Review of Reactor Pressure Vessel Evaluation Report for Yankee Rowe Nuclear Power Station (YAEC No. 1735)

Prepared by
R. D. Cheverton, T. L. Dickson, J. G. Merkle, R. K. Nanstad

Oak Ridge National Laboratory

Manuscript Completed: October 1991
Date Published: March 1992

Figure D.7. VISA-II and OCA-P predicted hoop stress distributions at time = 10 min. for Yankee Rowe SBLOCA7 PTS event (R/w -7).

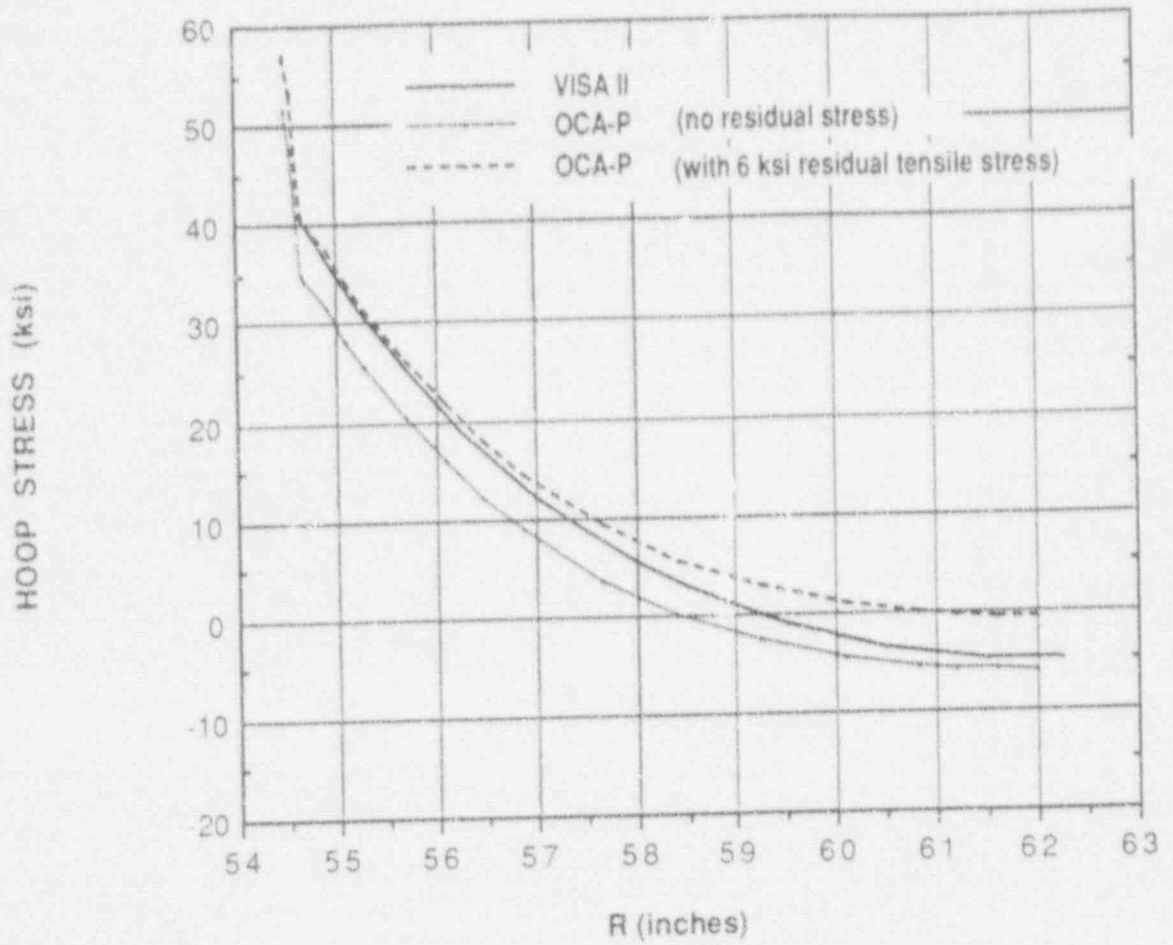
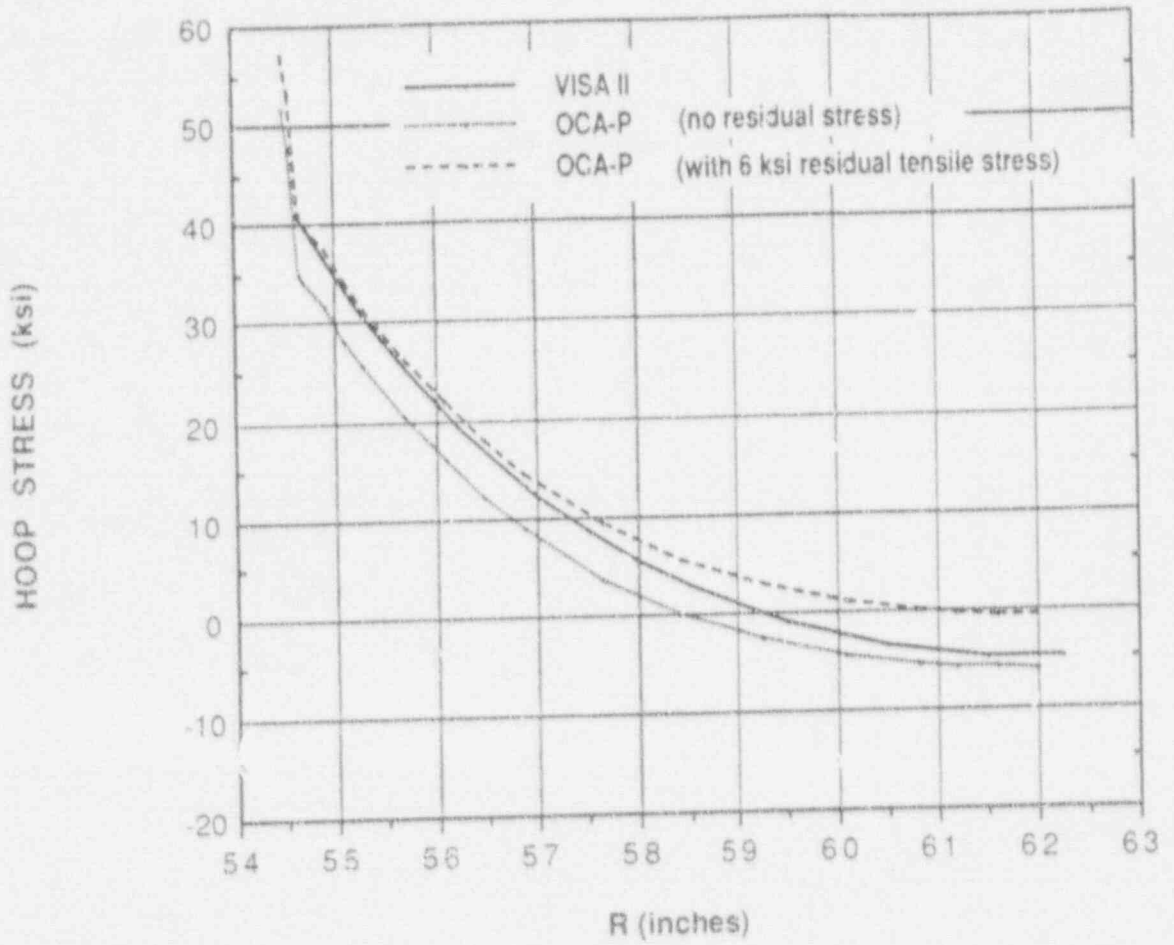
Figure D.7 shows the hoop-stress solutions predicted by VISA-II and OCA-P for the Yankee vessel when subjected to the SBLOCA7 transient. Both of the OCA-P hoop-stress solutions illustrated in Fig. D.7 included the 0.109-in. cladding; the VISA-II solutions did not. The higher of the two OCA-P solutions includes a weld residual tensile stress of -6 ksi.
